HYUNDAI

Technical Service Bulletin

GROUP RECALL	NUMBER 13-01-033-1
DATE AUGUST 2013	MODEL(S) Azera (HG)

SUBJECT: AZERA PODS UPDATE (RECALL 111)

PODS REPLACEMENT PROCEDURE

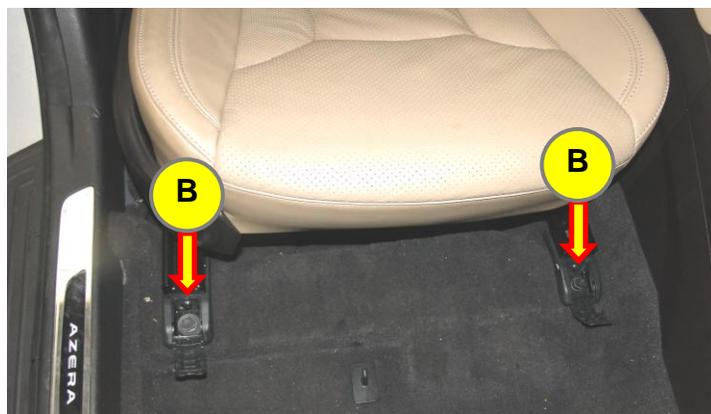
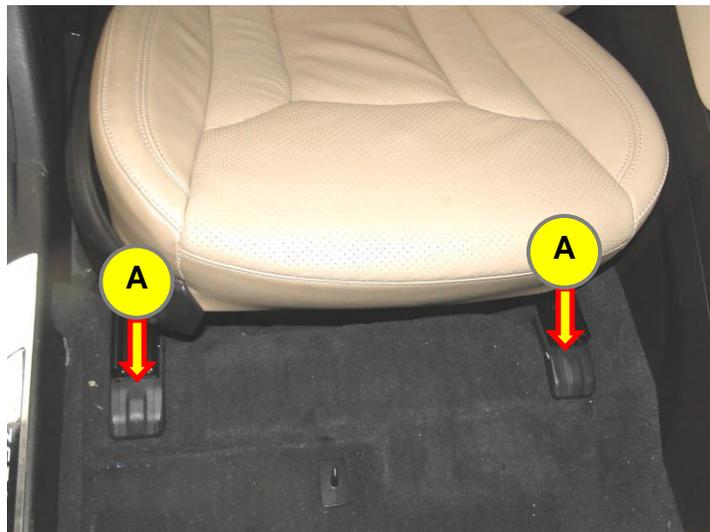
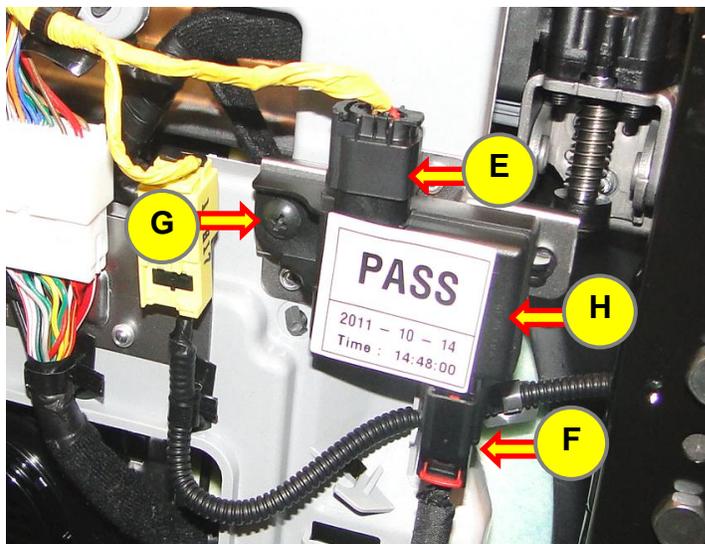
- 24) 1. Move the front passenger seat to the most rearward position.
2. Set the engine start/stop button to the "OFF" position.
3. Open the covers (A), and then remove the front mounting bolts (B) of the front passenger seat.

4. Move the front passenger seat to the most forward position.
5. Open the covers (C), and then remove the rear mounting bolts (D) of the front passenger seat.

6. Lift the front part of the seat, and then disconnect the PODS connectors (E, F). (Do not remove the seat from the vehicle.)

7. Remove the mounting screw (G), and then remove the PODS (H).

8. Install the new PODS (88952-3V600-QQH).
